August 22, 1980
ST-HL-AE-515
SFN: V-0530

South Texas Project
Units 1&2
Docket Nos. STN 50-498, STN 50-499
Additional Information on the
Safety Injection System Piping
Deficiency

FIGURE - 1

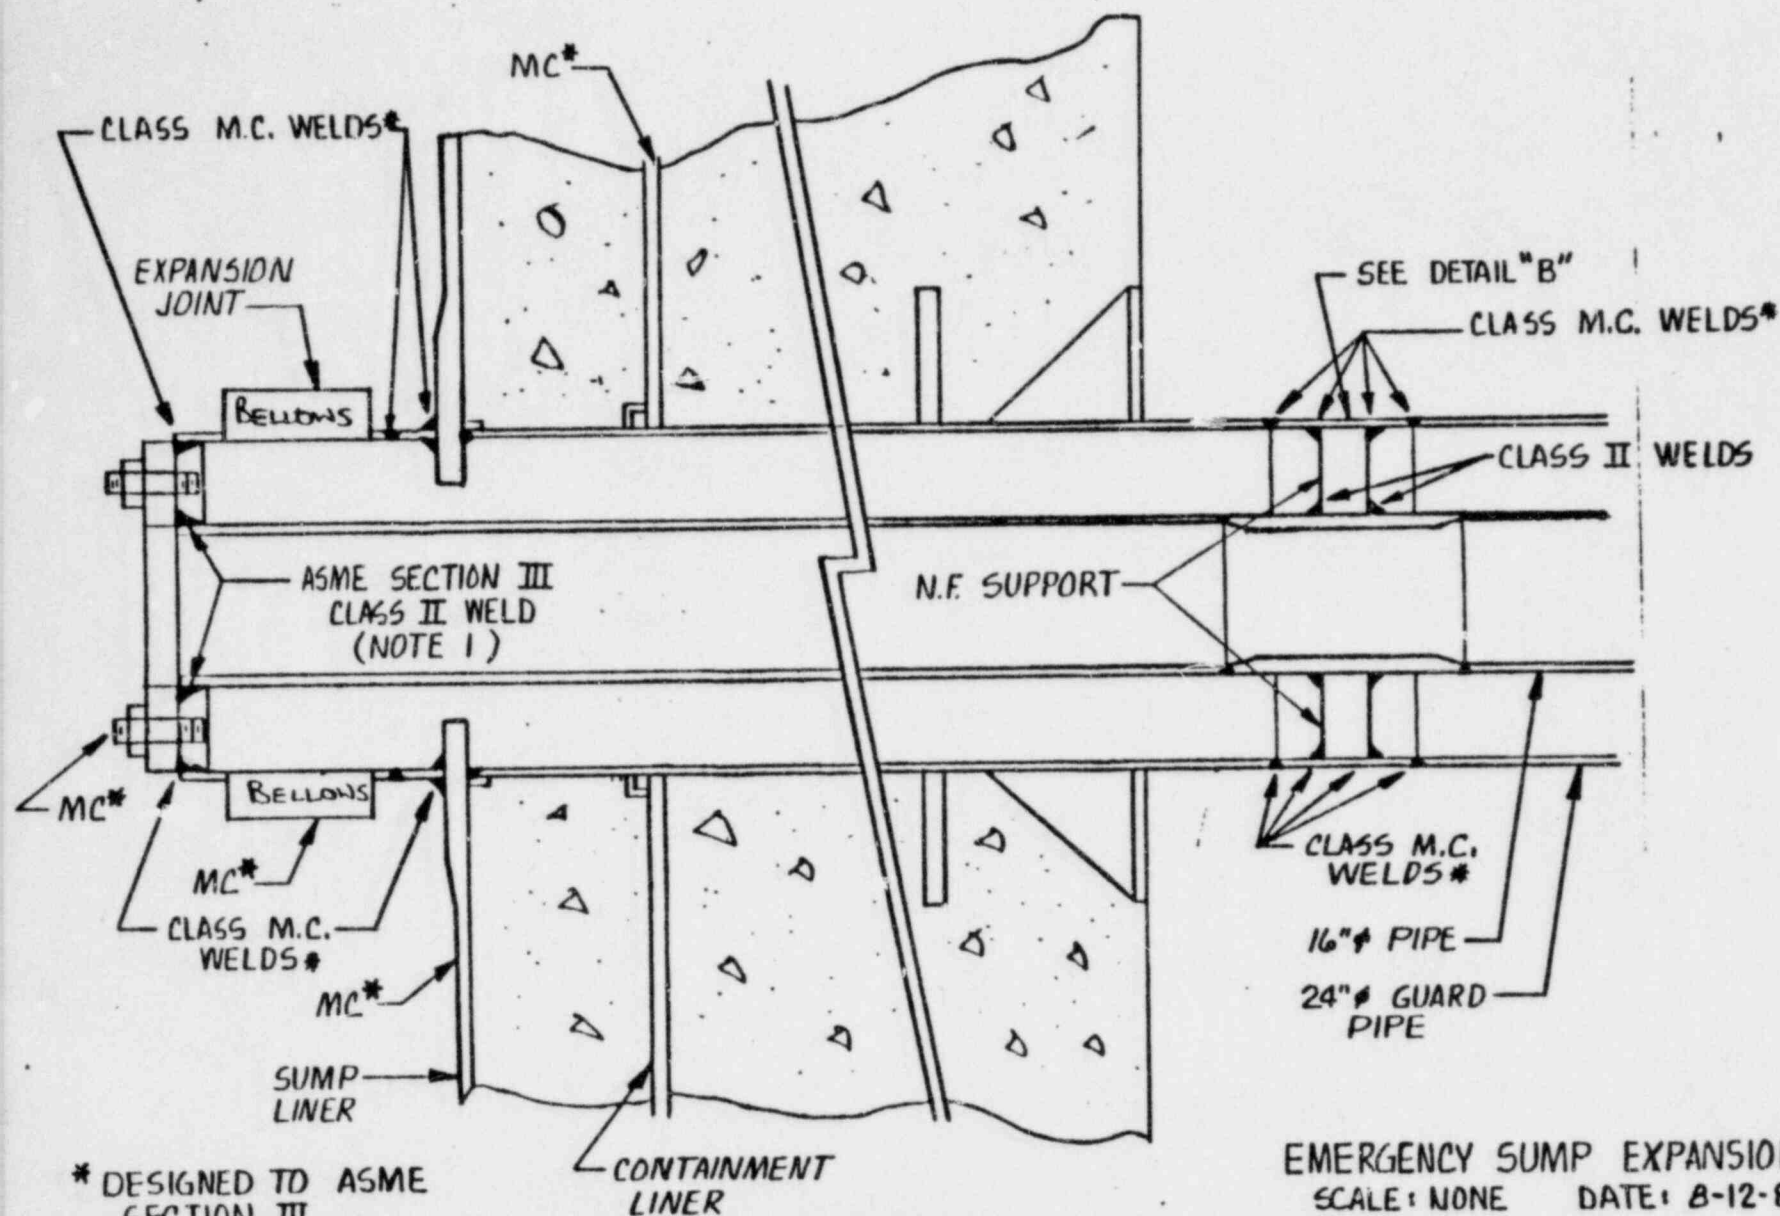
On May 30, 1980, pursuant to 10CFR50.55(e), Houston Lighting & Power Company submitted to your office a final report on the "Safety Injection System Piping Deficiency." On July 17, 1980, HL&P received a request for additional information concerning clarification of penetration details as shown on Figure 1 of the subject final report. Specifically, the clarification was to address disposition of the seal weld between the process pipe and the emergency sump lines. In response to your request for additional information on the subject deficiency, please find attached the following information.

Figure 1 depicts the general layout of the Safety Injection System (SIS) piping with the expansion joints and pipe restraints located. This figure is similar to Figure 1 of our final report.
